# ETE Road Map

## Item 2 Qualification of Valves Preliminary Monitoring Report

Report to the Federal Ministry of Agriculture,  
Forestry, Environment and Water Management  
of Austria

Vienna, May 2003

Figure 3 BRU-A Valve type Chekhov Type 1115-300/350 (WVER-1000)

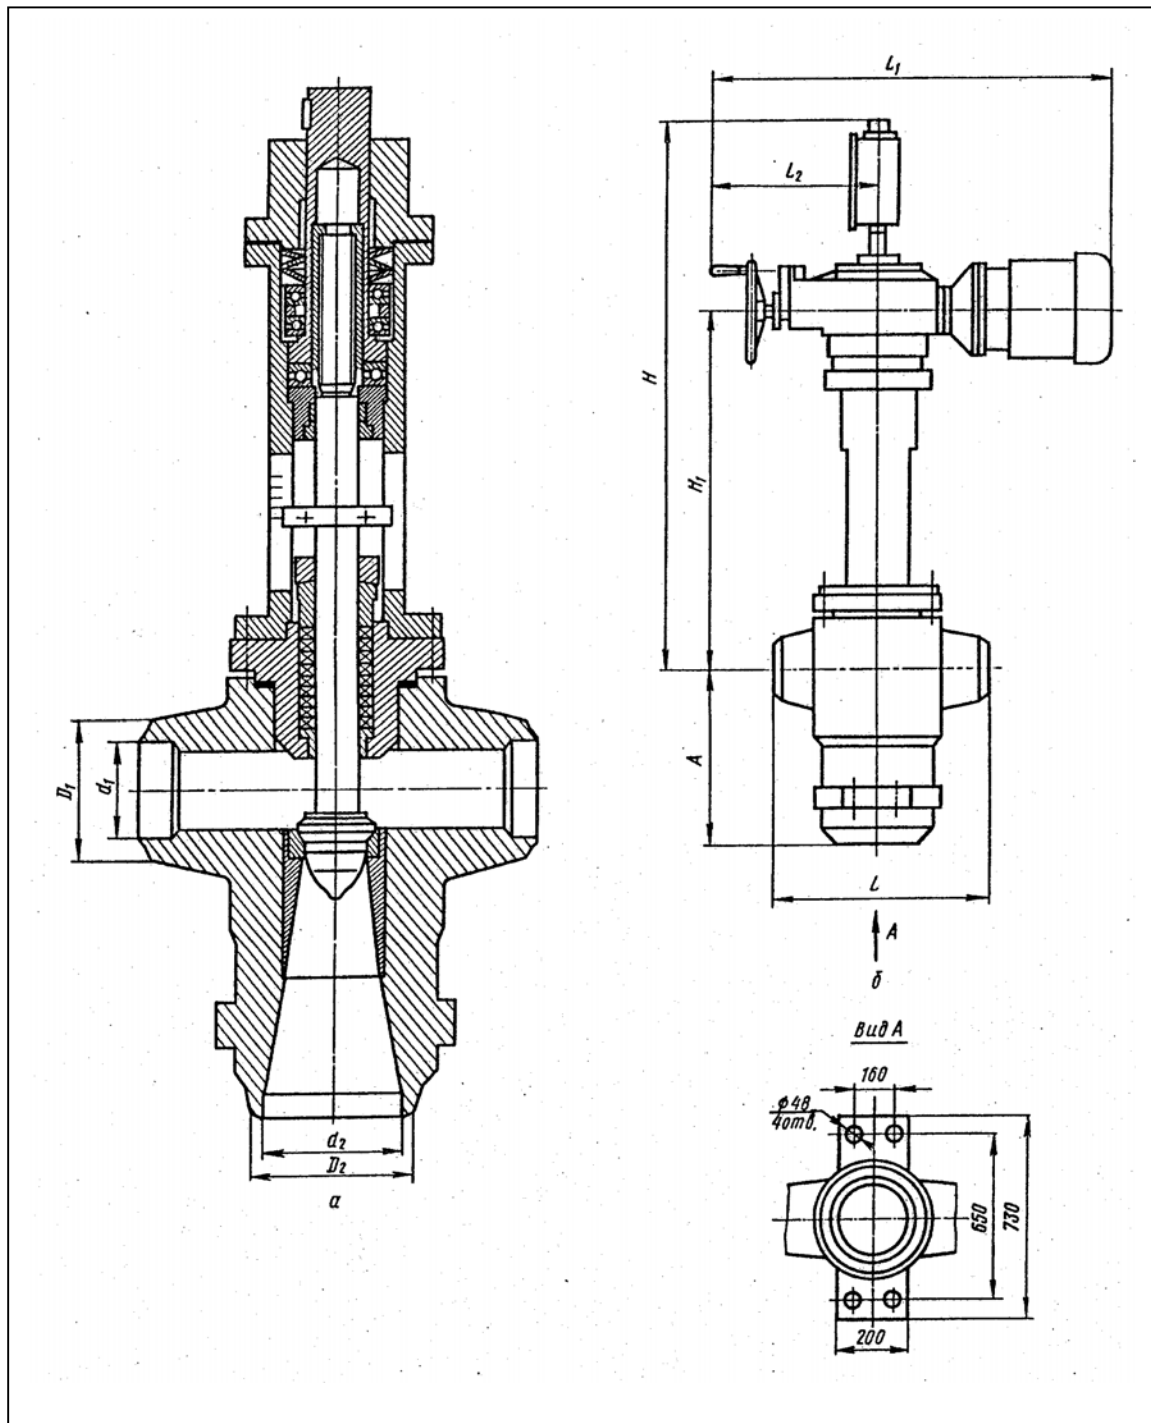
- The ASME code requires, beside other defined test conditions, that tests have to be planned. The parent BRU-A was actuated at one occasion, which seems to have been a spurious event rather, than a test under planned conditions for two-phase flow, because two-phase flow conditions developed quite unexpectedly, as reported by the TSO at the Workshop. Inasmuch as there is only a single and unplanned two-phase flow test of the parent BRU-A valve, the Temelín candidate BRU-A valve cannot be considered to be qualified for two-phase flow.

- Similarity demonstration by tests is not the only method allowed in the context of valve qualification. QVP-7200 of ASME code [ASME 1994] states that analytical methods are allowed as well. In the context of the present case, this means comprehensive analyses using well-tested and verified computer codes. Such analyses may replace some tests and may be used for the extension. This is common European practice. The results of the analyses by the computer code must compare well with all test results (verification of the code). These codes allow the missing tests to be simulated; they must also be used to extensively check the load cases in the real plant (where the candidate valve is installed).

The tests should be performed for the actual Temelín valves (together with the new actuator in the case of the BRU-A and the new pilot valve in the case of the MSSV), because otherwise two parent valves for each type of valves will have to be tested for compliance with ASME code requirements. The test conditions should, to the extent possible, represent actual plant conditions under which the "candidate" valves should be operable. (Test for water flow at a temperature of about 300°C, as encountered with large primary to secondary leaks, instead of 100°C as was done in the test of the MSSV "parent" valve (see APPENDIX II)).
